PD Modification Application: PRS 22-0730
Zoning Hearing Master Date: N/A
BOCC Land Use Meeting Date: October 11, 2022
1.0 APPLICATION SUMMARY

APPLICATION NUMBER: PRS 22-0730

Case Reviewer: Michelle Heinrich, AICP

2.3 Approved Site Plan (partial provided below for size and orientation purposes. See Section 8.1 for full site plan)

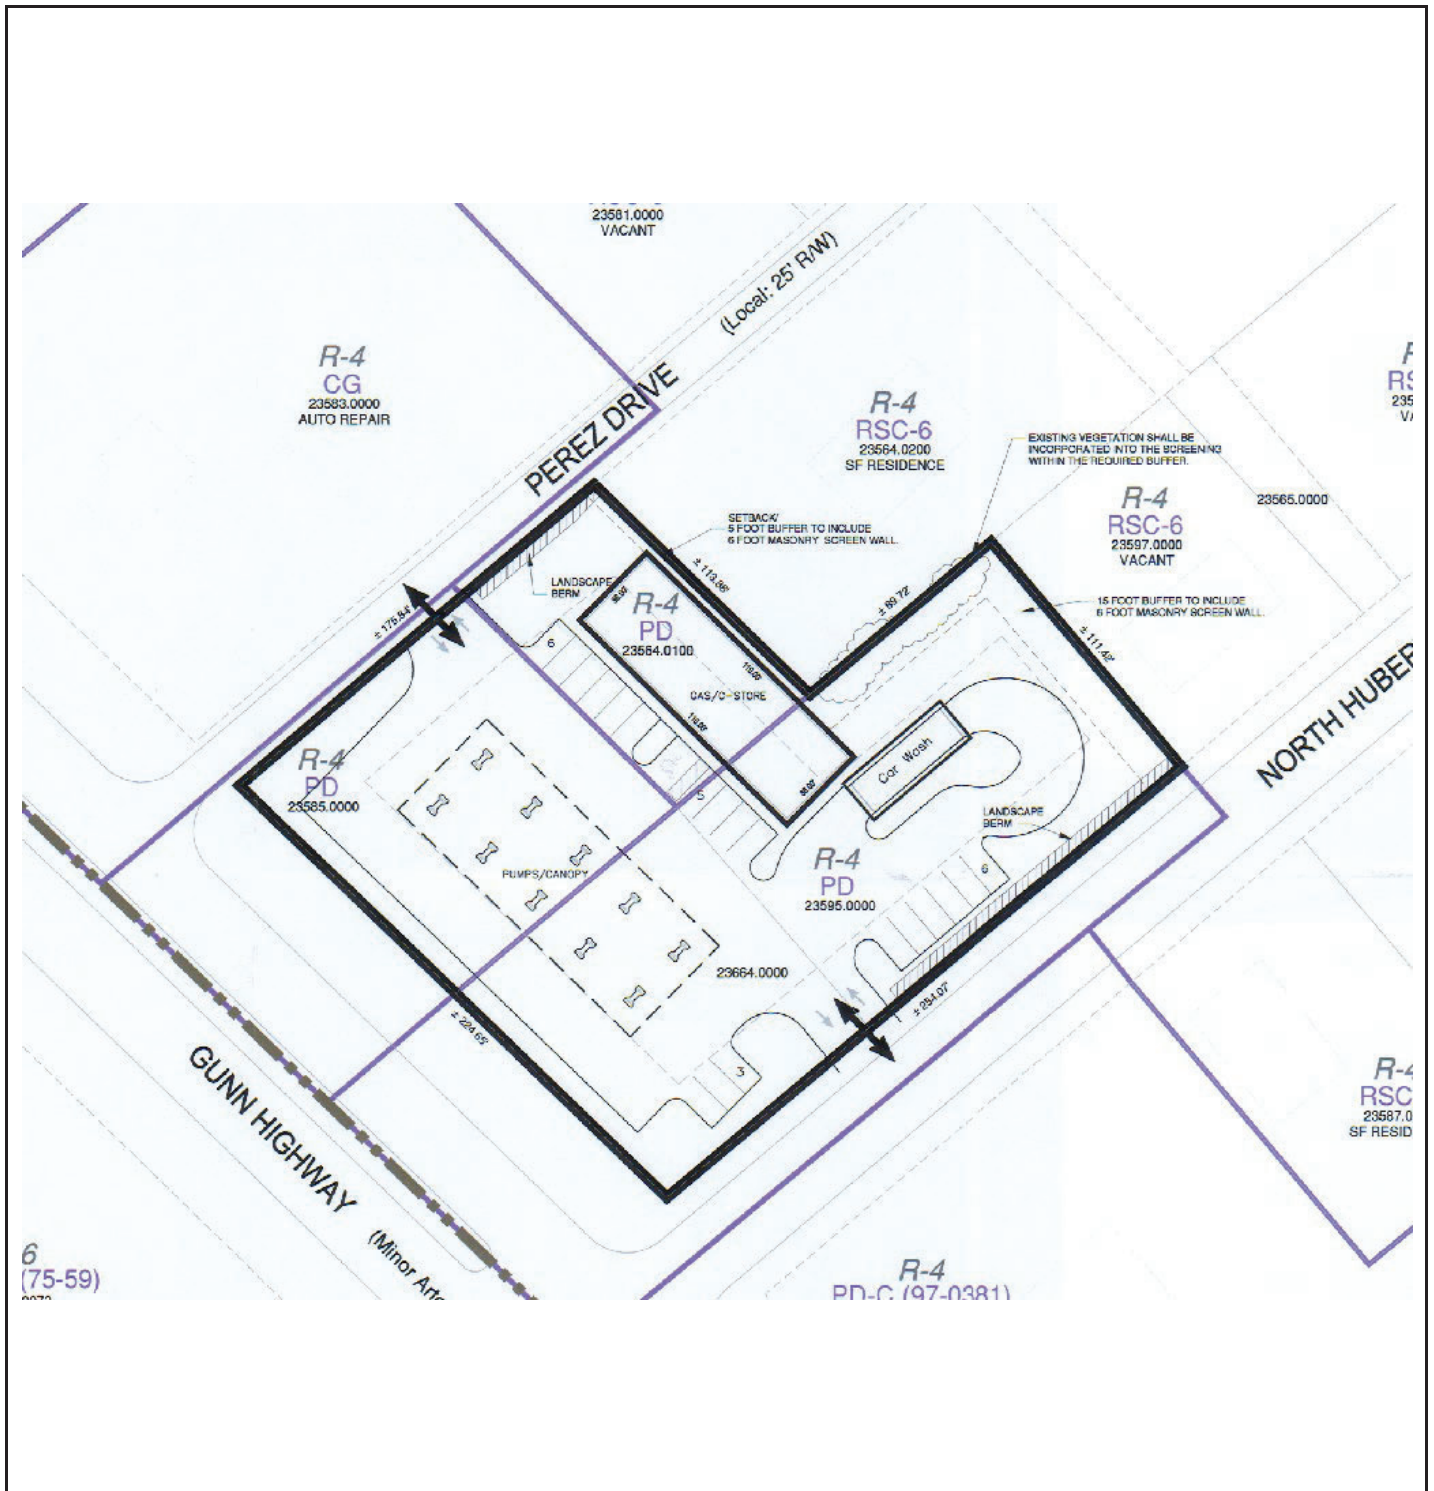
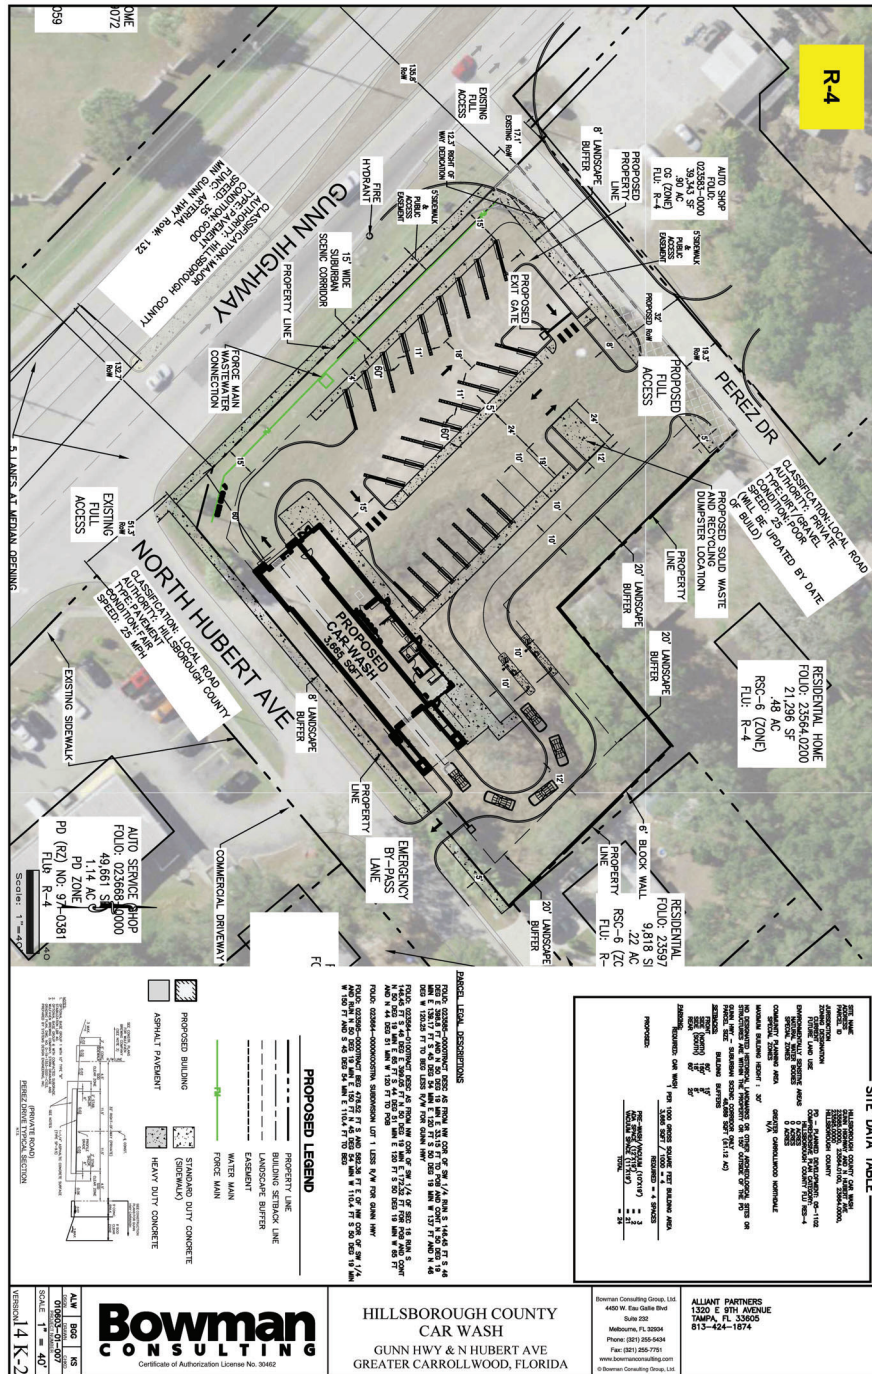
The applicant requests a revised layout specifically designed to accommodate a free-standing, automated carwash. The car wash building will be located along the eastern area of the PD (along N. Hubert Avenue). Two queuing lanes are proposed, which will be accessed via Perez Drive and will queue vehicles along the northern PD boundary. Cars will exit the site via Perez Drive after the car wash process. The Hubert Avenue access point will serve as an exit only. A significant portion of the site will be used for vacuum spaces and internal drives. Per the applicant, an attendant will be on-site to assist customers; however, no car detailing services will be provided.

Residential development is located to the north of the site, while commercial uses are located to the east and west. The proposed layout provides buffering and screening along the north, which exceeds what is currently required under the convenience store site plan and meets Land Development Code requirements. The required 8-foot-high landscape berms along Perez Drive and Hubert Avenue are no longer proposed. These areas are oriented towards commercial development found to the east and west and were required in conjunction with alternative buffering and screening along the north. The alternative buffering and screening consists of a 6-foot wide buffer with a masonry wall, as opposed to the Land Development Code required 20 foot wide buffer with Type B screening. With the provision of a 20-foot-wide buffer and Type B screening along the north, the appropriate areas of the site are addressed, and screening along Perez Drive and Hubert Avenue is no longer needed to compensate for the alternative buffering and screening along the north.

Approval of the request, subject to the conditions listed, is based on the revised general site plan submitted September 19, 2022.

2.4 Proposed Site Plan (partial provided below for size and orientation purposes. See Section 8.2 for full site plan)

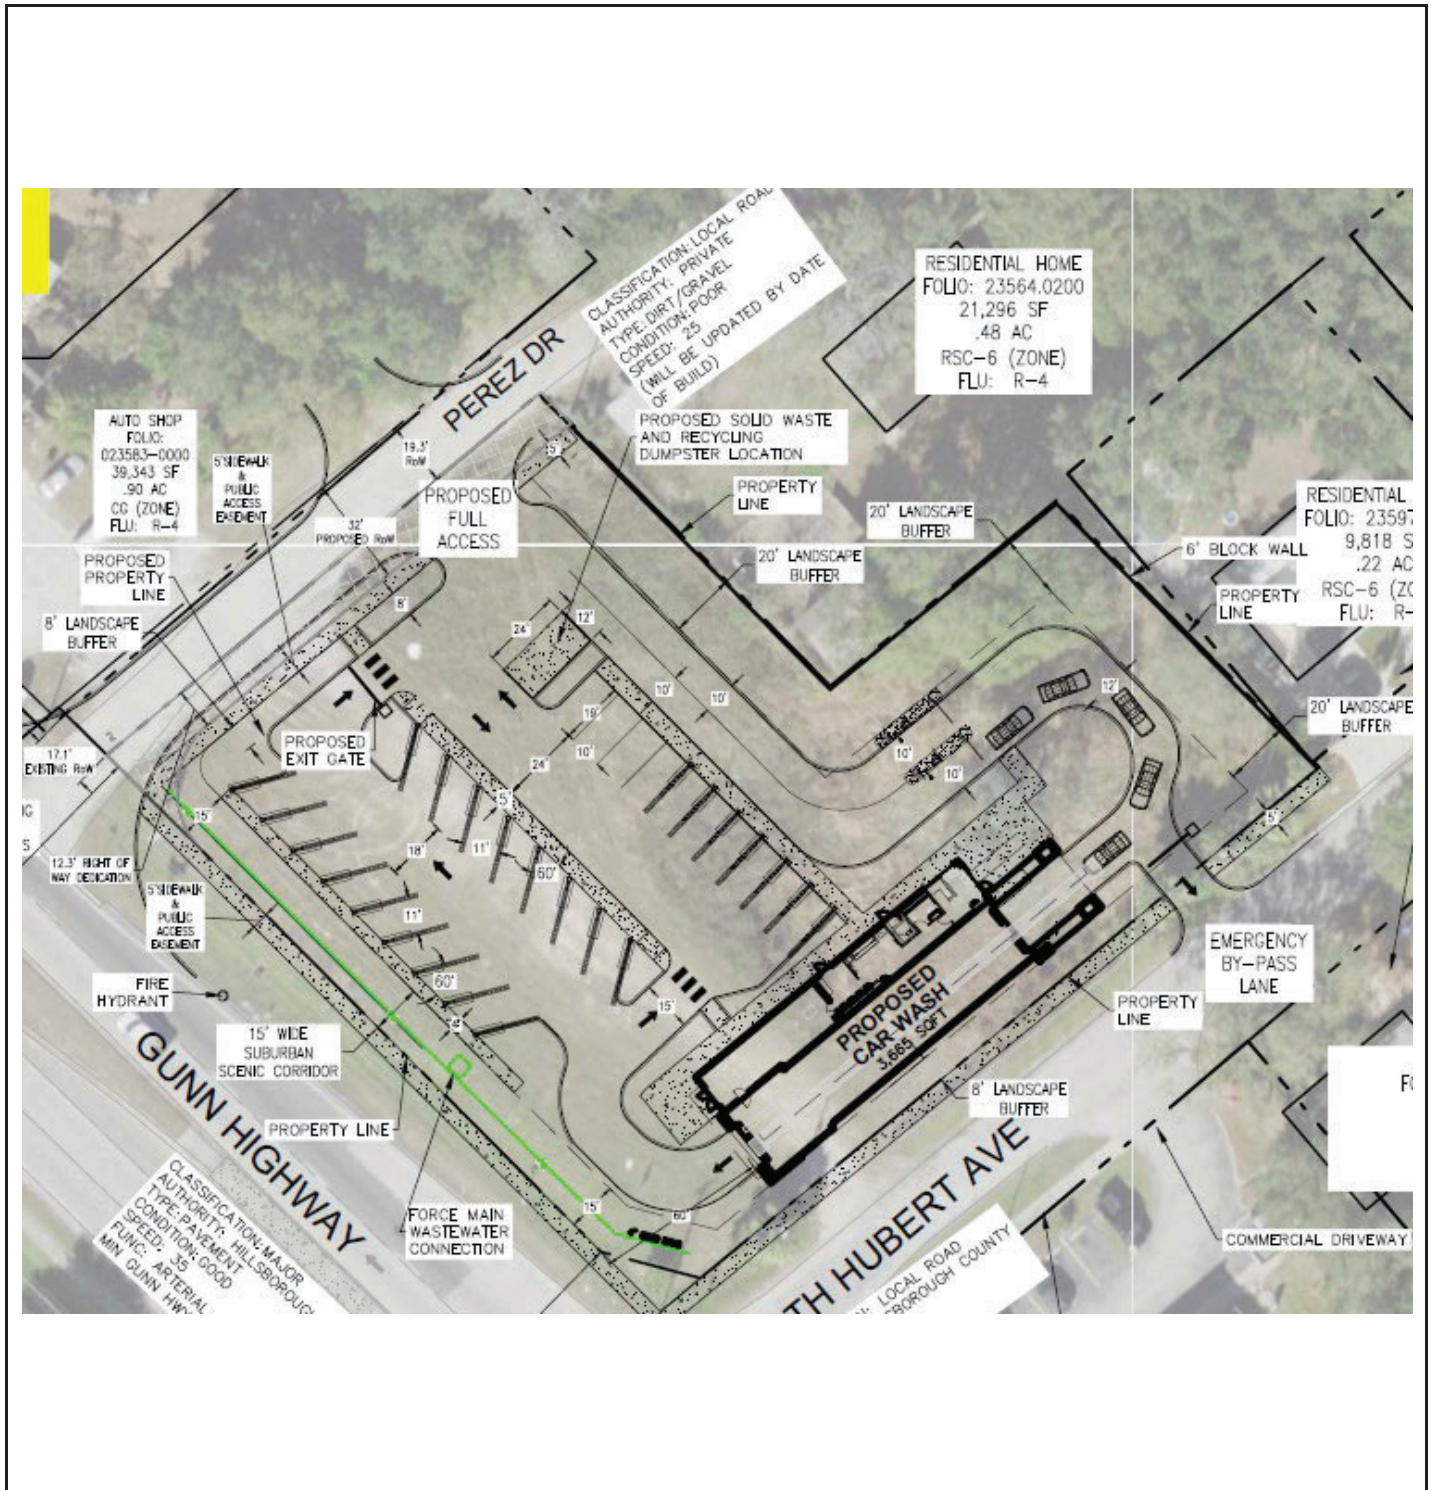
Previously approved requirements to enhance the development will remain. The project will maintain the requirement to have structures be residential in appearance, which includes the use of a pitched roof. Furthermore, the Suburban Scenic Corridor along Gunn Highway will be provided. This will provide a 15-foot-wide buffer with tree plantings, which can be modified to accommodate overhead electric utility lines.

Approvable, subject to proposed conditions.
